Access Compliance Report

Public Rights-of-Way

(Curb Ramps)

Intersection ID: 3853	Main Street: CADENCIA_CT	Cross Street: GLASTON_LN	Location: S
ADA ID: 9F545278C56E	Ramp Type: Perp	Initial Pass/Fail: Pass	Overall Compliance: No
		Severity Score: 30

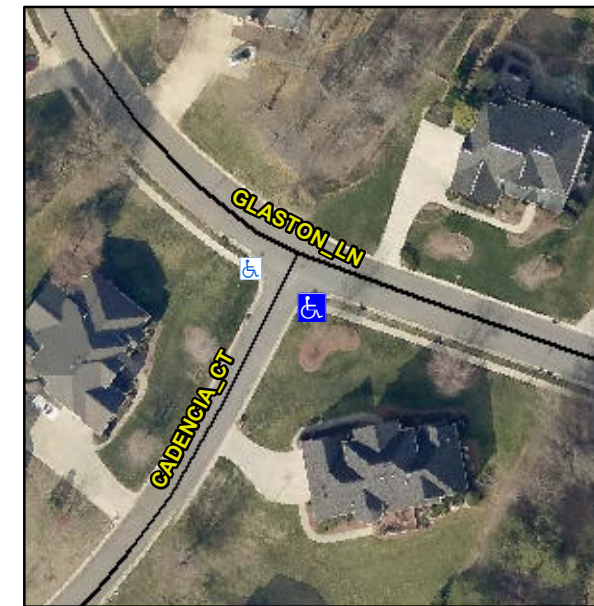
R304.5.3, R305, R302.7.2, R304.5.4

Compliance	Description	Data	Compliance	Description	Data
N/A	Ramp Length (in)	42.0	Yes	Ramp Slope (%)	5.5
Yes	Ramp Width (in)	48.0	Yes	Ramp XSlope (%)	1.7
N/A	Flare Type LT	Sloped	N/A	Flare Type RT	N/A
N/A	Flare Slope LT (%)	1.4	N/A	Flare Slope RT (%)	6.8
N/A	Flare Traversable LT?	Yes	N/A	Flare Traversable RT?	No
Yes	Landing Length (in)	53.0	No	DWS Provided?	No
Yes	Landing Width (in)	86.0	N/A	DWS Contrast?	No
Yes	Landing Slope (%)	1.2	N/A	DWS Length (in)	N/A
No	Landing X Slope (%)	2.3	N/A	DWS Full Width?	No
N/A	Landing Curb? (Y/N)	No	N/A	DWS Offset (in)	N/A
N/A	Shared Landing?	No			
Yes	Gutter Ponding?	No	No	Gutter Slope (%)	6.7
No	Gutter Lip Ht (in)	1.0	No	Gutter X Slope (%)	3.7
N/A	Painted X Walk1?	No	N/A	Painted X Walk2?	N/A
	X Walk 1 Direction	To NW		X Walk 2 Direction	N/A
N/A	X Walk 1 Width (in)	N/A	N/A	X Walk 2 Width (in)	N/A
	X Walk 1 Slope (%)	7.3		X Walk 2 Slope (%)	N/A
	X Walk 1 X Slope (%)	2.9		X Walk 2 X Slope (%)	N/A

**Remove & Replace Entire Ramp.
Remove & Replace Gutter.**
